***MODIFICATION REQUEST:  
Marrickville Metro Shopping Centre  
Expansion – Concept Plan (Stage 1)***

***Marrickville Metro – 34 Victoria Road and 13-55  
Edinburgh Road, Marrickville***

***MP09\_0191 MOD1***

Director-General's  
Environmental Assessment Report  
Section 75W of the  
*Environmental Planning and Assessment Act 1979*

Figure 5: Smidmore Street: approved elevation (above) modified elevation (below) (Source: Concept Plan MP09\_0191 and Proponent's Environmental Assessment)

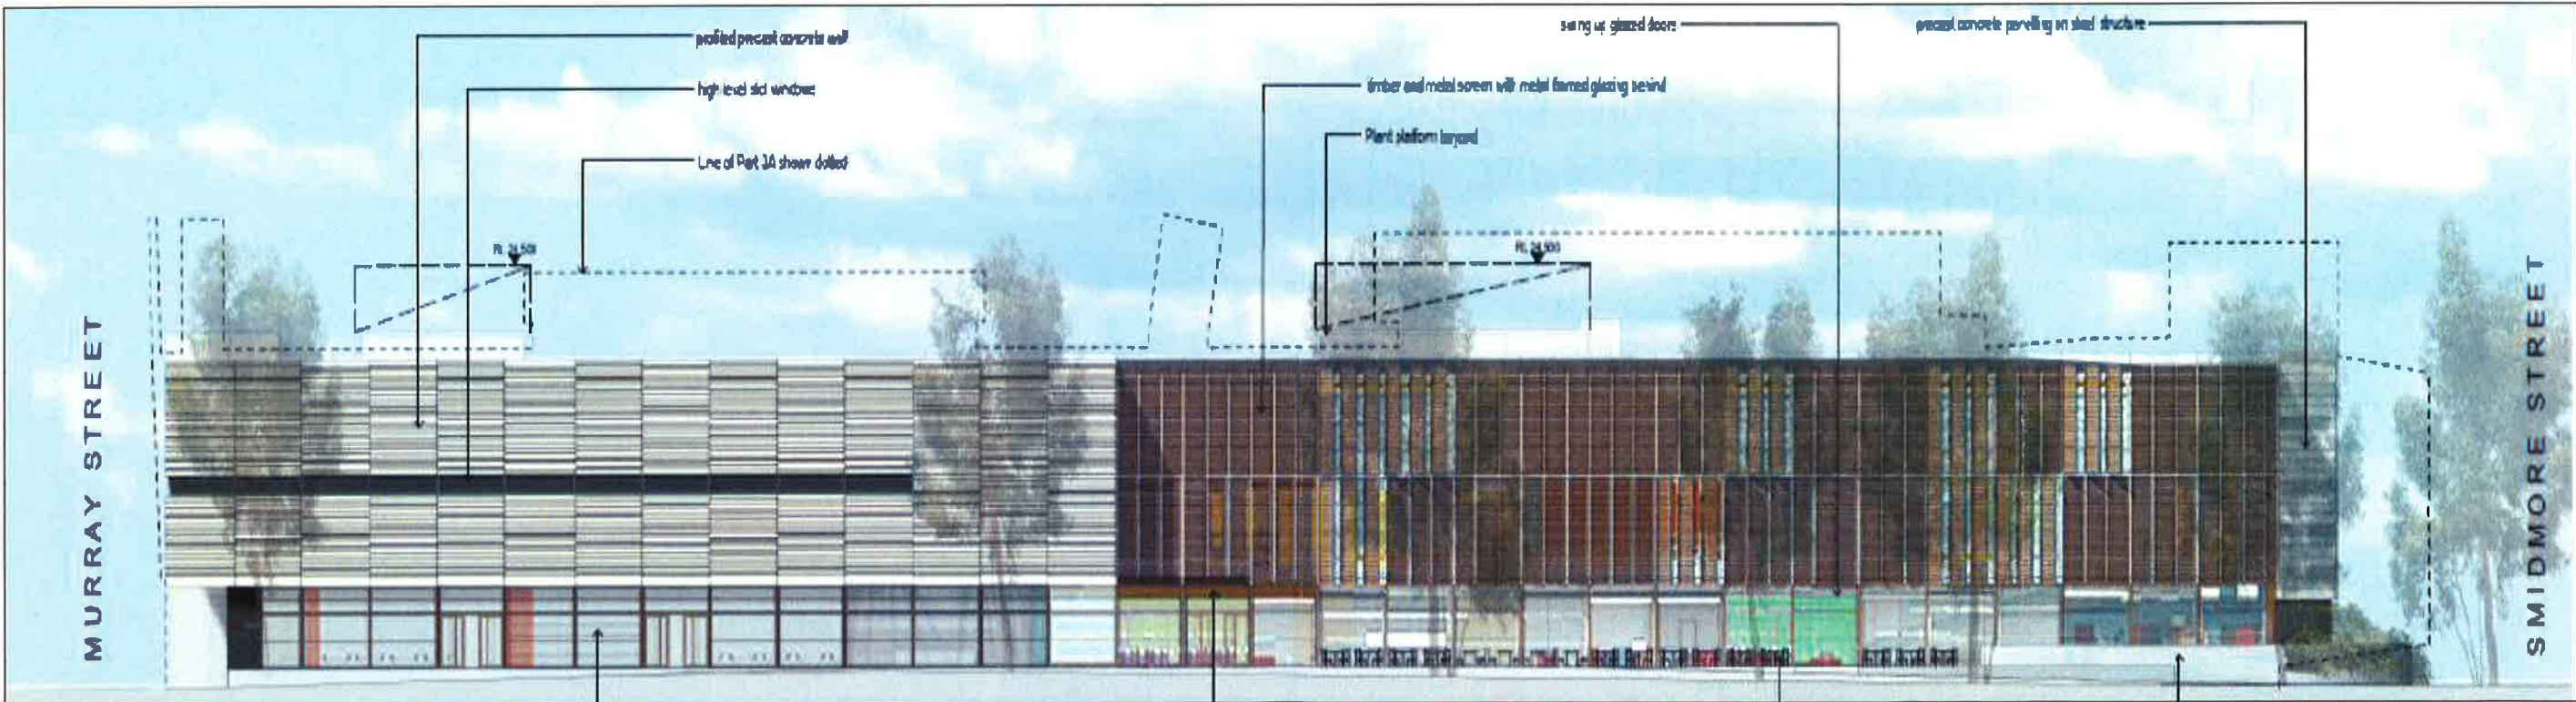
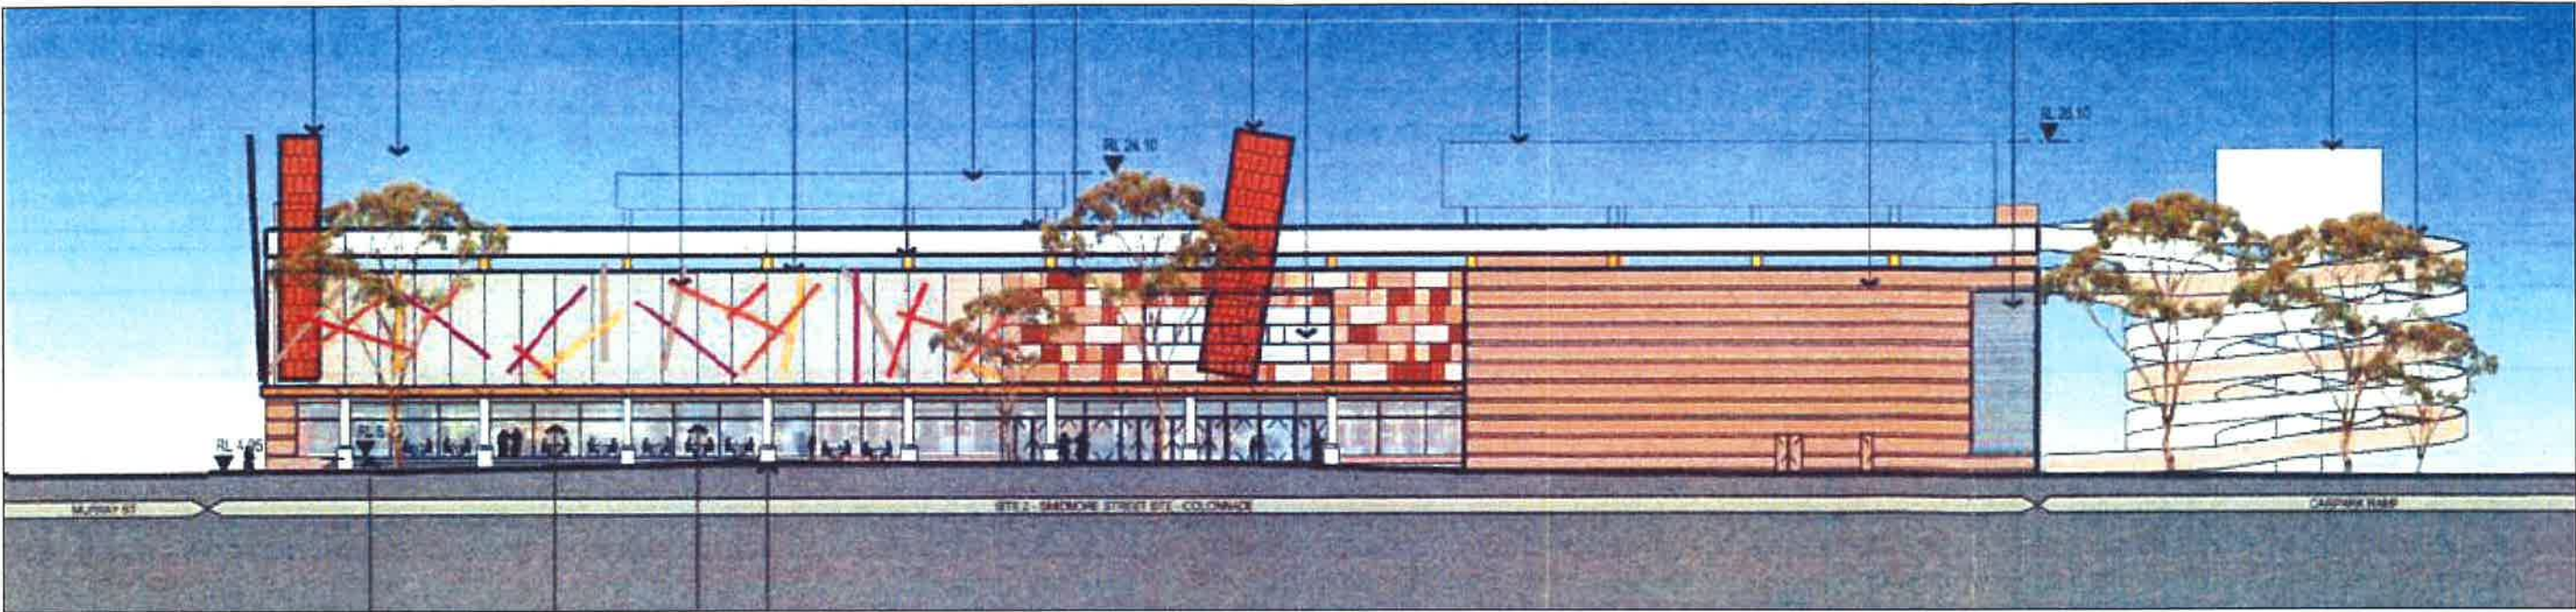
- increased building set back from Smidmore Street by 5 metres, together with creation of outdoor seating area, retail activation along Smidmore Street and internal double height void space;

The currently approved building design provides a frontage (with no set back) to Smidmore Street, which is occupied by two large retail units. The Smidmore Street frontage is somewhat disconnected from the public domain by accessibility ramps, a substation and ancillary services. A large circular vehicular access ramp occupies the western portion of the site (discussed below). As a result the building is relatively inward facing/focused in terms of its configuration and circulation.

With reference to Council's suggestion of a provision of smaller retail tenancies at this frontage, the Department notes that the approved Concept Plan allows for the creation of two large retail tenancies. The modification proposes the creation of one tenancy with the remainder of the ground floor frontage accommodating the market area (which is comprised of numerous small stalls) (refer to **Figure 3 and 5**). The Department considers the market area, with its stalls and associated outdoor seating, together with the single retail tenancy would adequately activate Smidmore Street and when compared to the approved Concept Plan would provide an improved ground floor retail experience.

The Department considers that the reconfiguration of floor space and expansion of the building to the western boundary, as noted above, represents an improvement over the approved development as it replaces a vehicle ramp with a high quality pedestrian environment. The resulting Edinburgh Road building will have a more open, engaging and permeable appearance, and the reconfigured internal spaces will make way-finding easier for pedestrians and shoppers. The removal of the vehicular ramp and extension of the building westward is considered to have a positive visual impact which would be beneficial to the residential amenity of properties west of the Edinburgh Road site.

Figure 6: Edinburgh Road: Approved elevation (with circular ramp) (left) modified elevation (and ramp access) (right) (Source: Concept Plan MP09\_0191 and Proponent's Environmental Assessment)

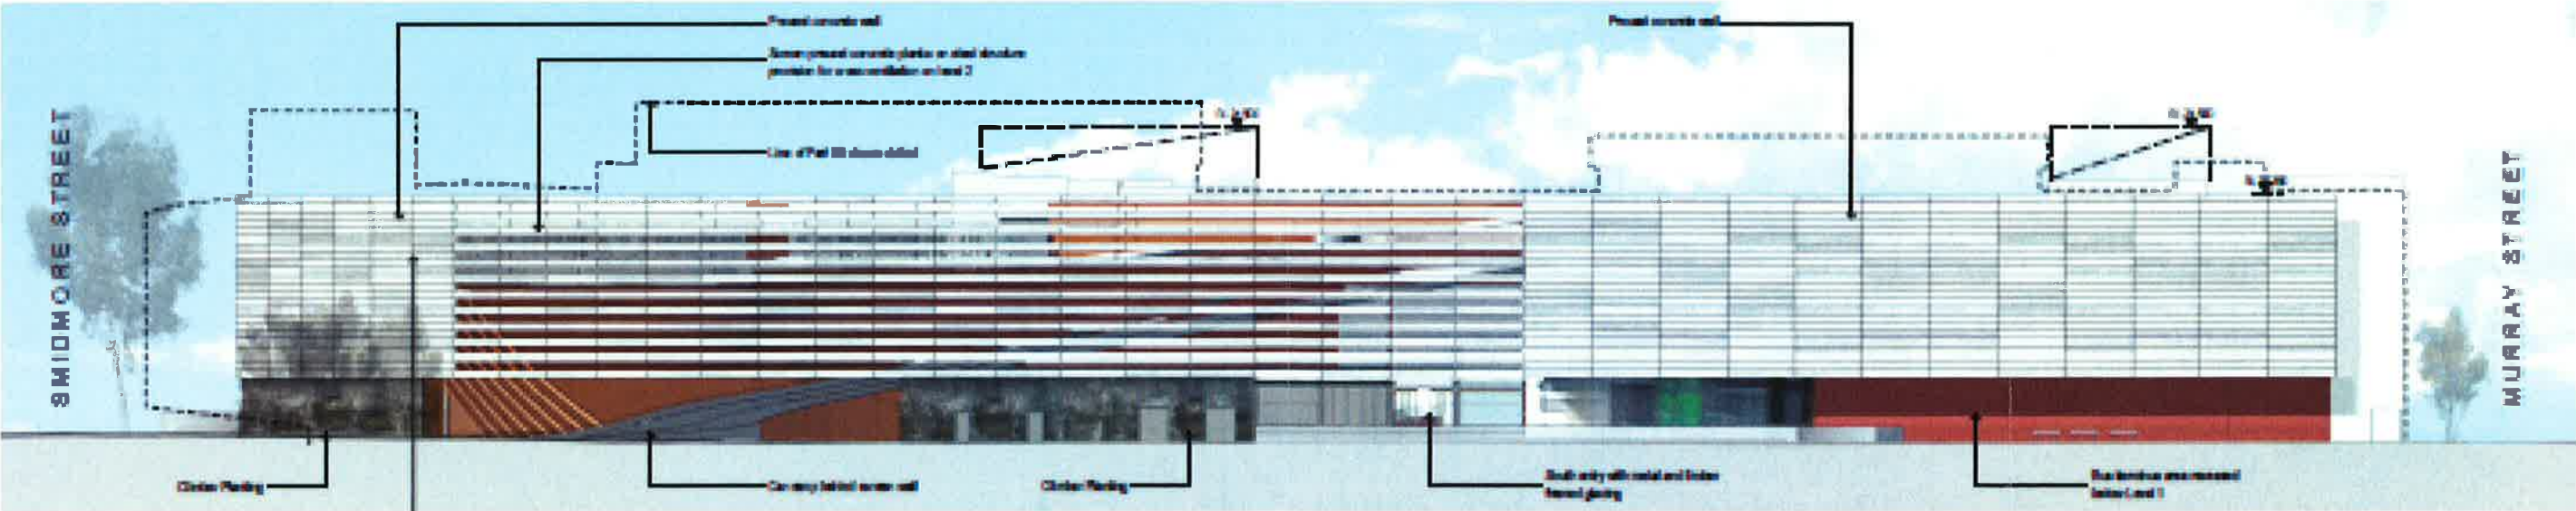
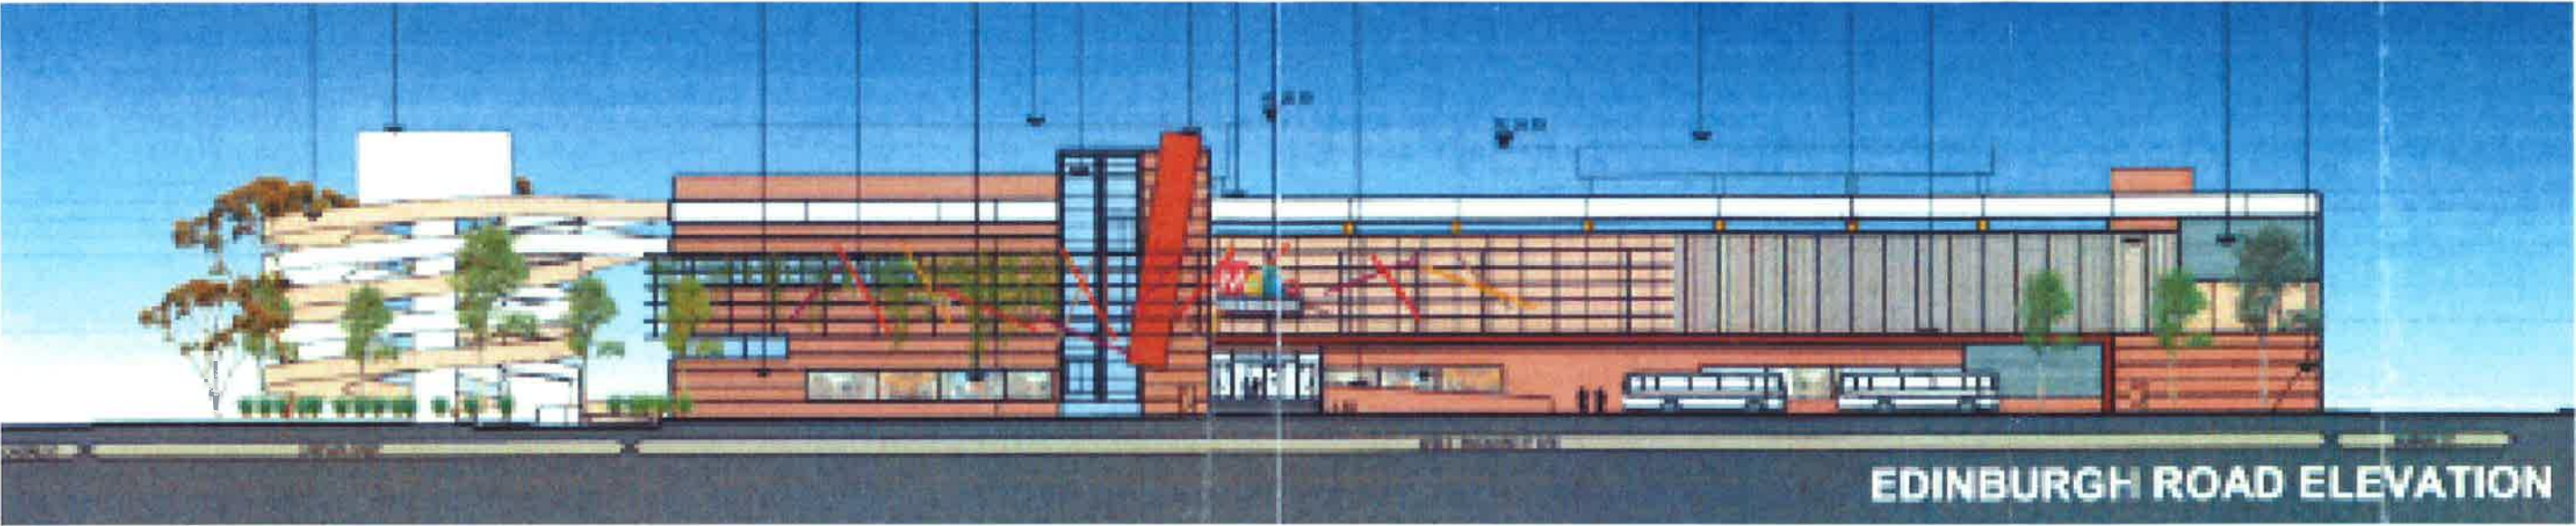
Access to the roof top car parking spaces within the Edinburgh Road site, as approved, is provided via a circular vehicular access ramp at the intersection of Smidmore Street and Edinburgh Road (western end of the site). The modification seeks the removal of the circular access ramp, expansion of the footprint of the building westward and inclusion of a redesigned access ramp. The revised ramp would be accessed from Edinburgh Road at the same cross-over point as the approved ramp. The ramp would rise behind the face of the southern facade, which is proposed to be treated with a slatted screen wall (refer to **Figure 3 and 6**)

The Department notes that Marrickville Council supports the replacement of the circular vehicular ramp. Having reviewed this aspect of the proposal, the Department considers that the removal of the circular vehicular ramp and replacement with the extended centre represents a significant improvement in urban design terms, particularly given the approved ramp's likely visual dominance and its prominent corner location. The revised ramp, which would rise along the face of the southern facade behind a slatted screen wall, is considered to be visually discrete and likely to be easier for future motorist to navigate.

Figure 7: Murray Street: Approved elevation (left) modified elevation (right) (Source: Concept Plan MP09\_0191 and Proponent's Environmental Assessment)

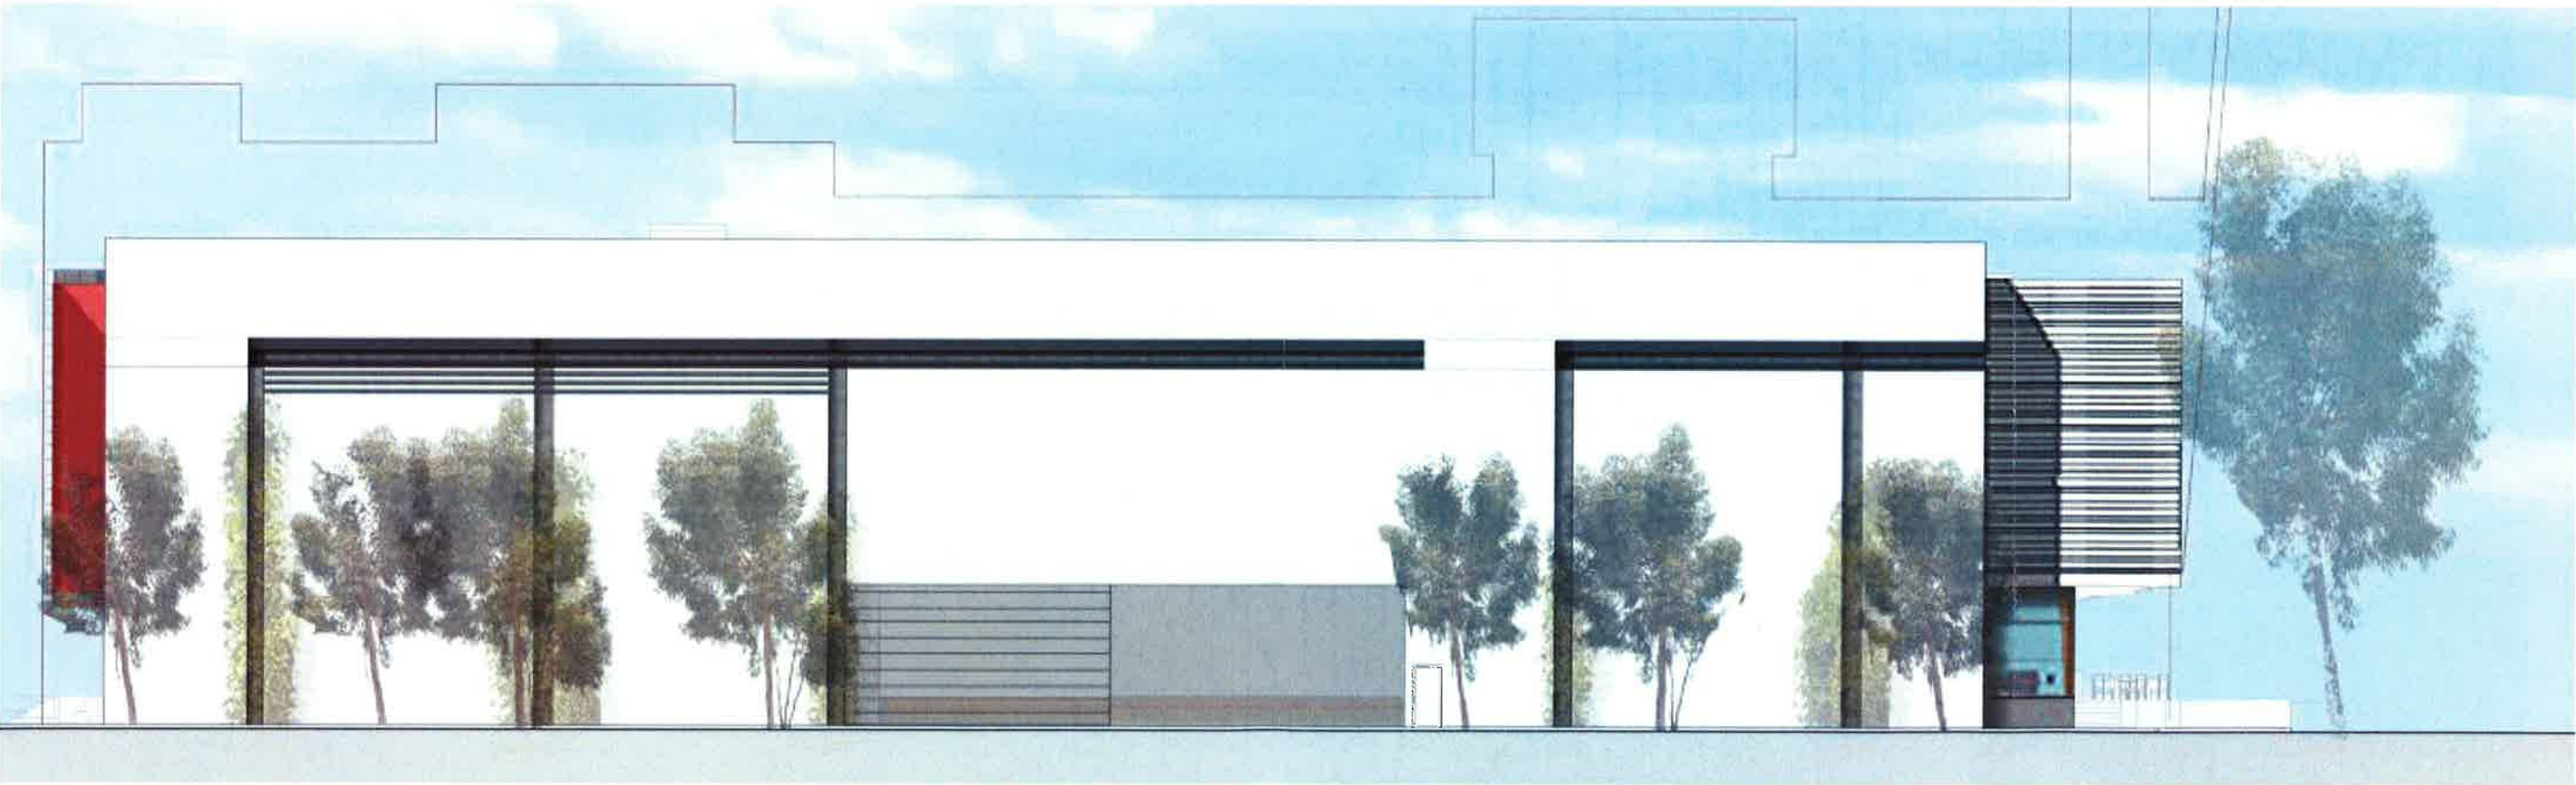
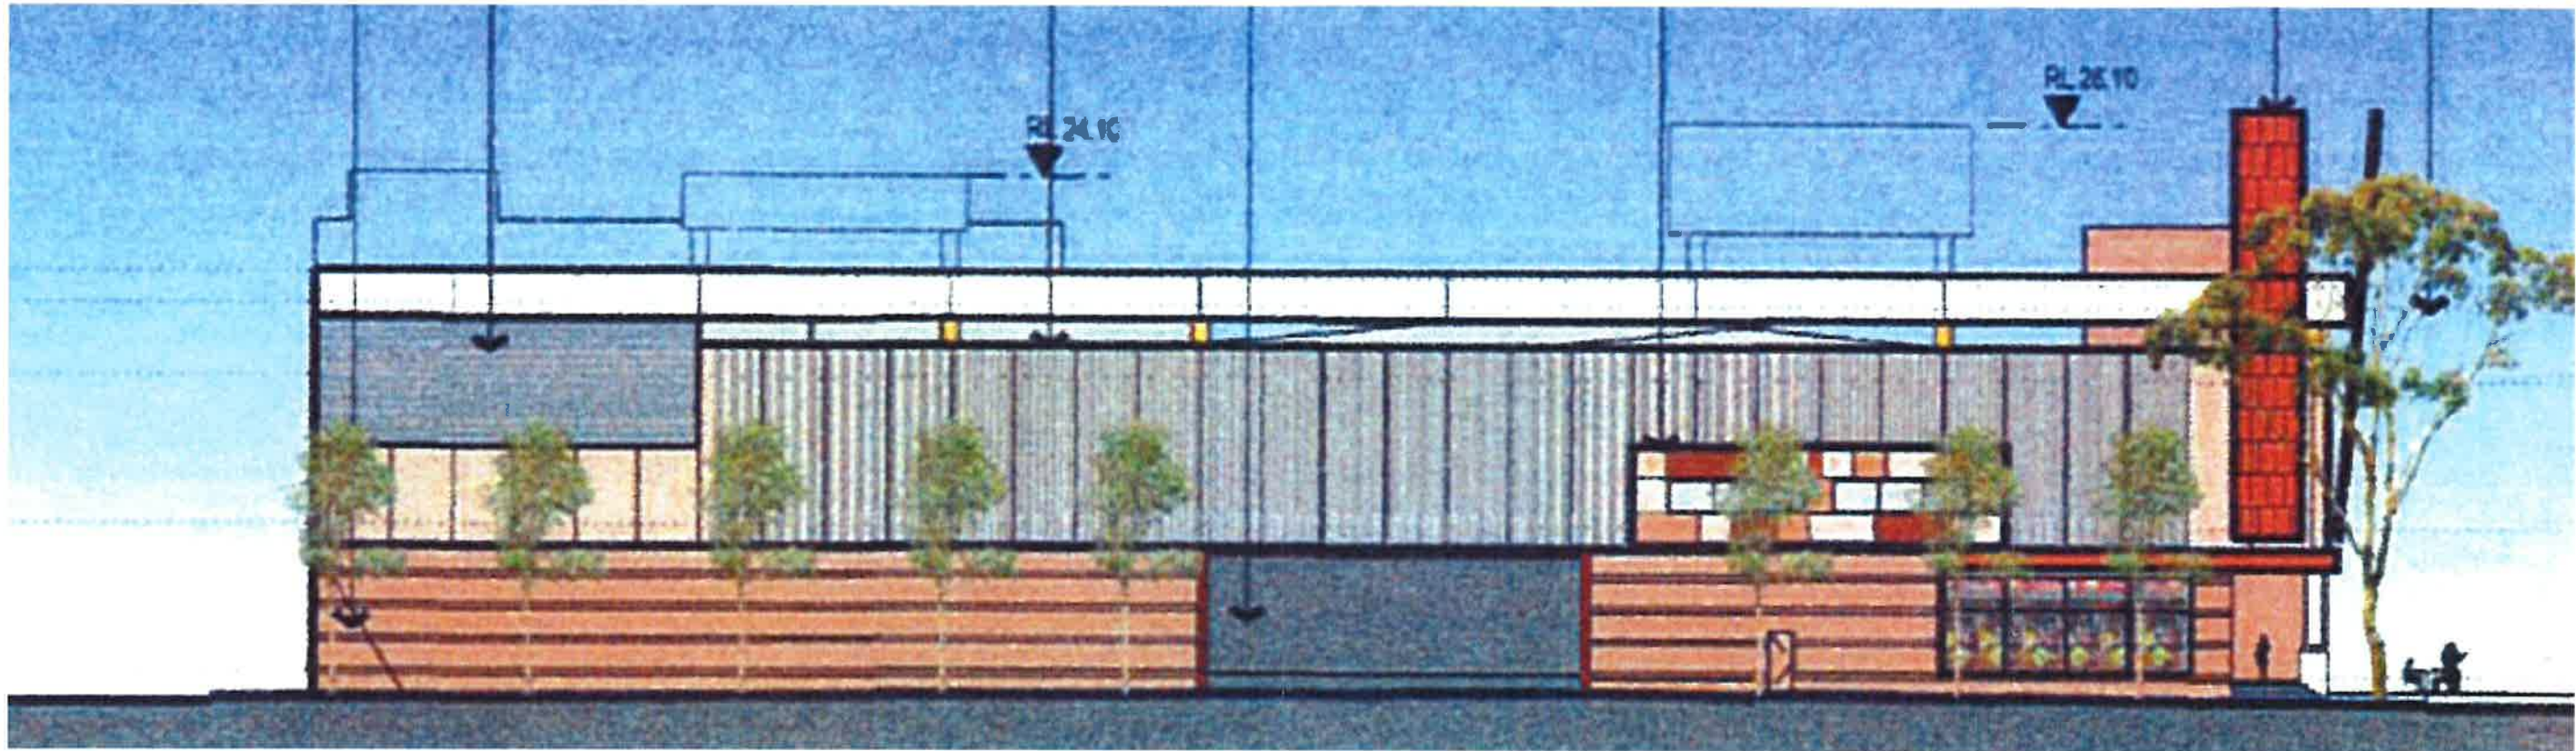
The proponent has stated that the above changes to building height are a result of the broader redesign of the elevations. The amendments also ensure that uniform parapet heights are established for each elevation and, in the case of Murray Street, an otherwise conspicuous roof top fire escape stair is concealed.

The Department considers that the proposed alterations to the approved building heights are of a minor nature when considered against the approved 14.7 metre building height. In regards to 900mm height increase at Murray Street the Department notes that:

- the façade faces onto an industrial estate;
- the resulting revised façade design represents an improvement over the approved design.

The Department therefore considers that the proposed height increase is acceptable.
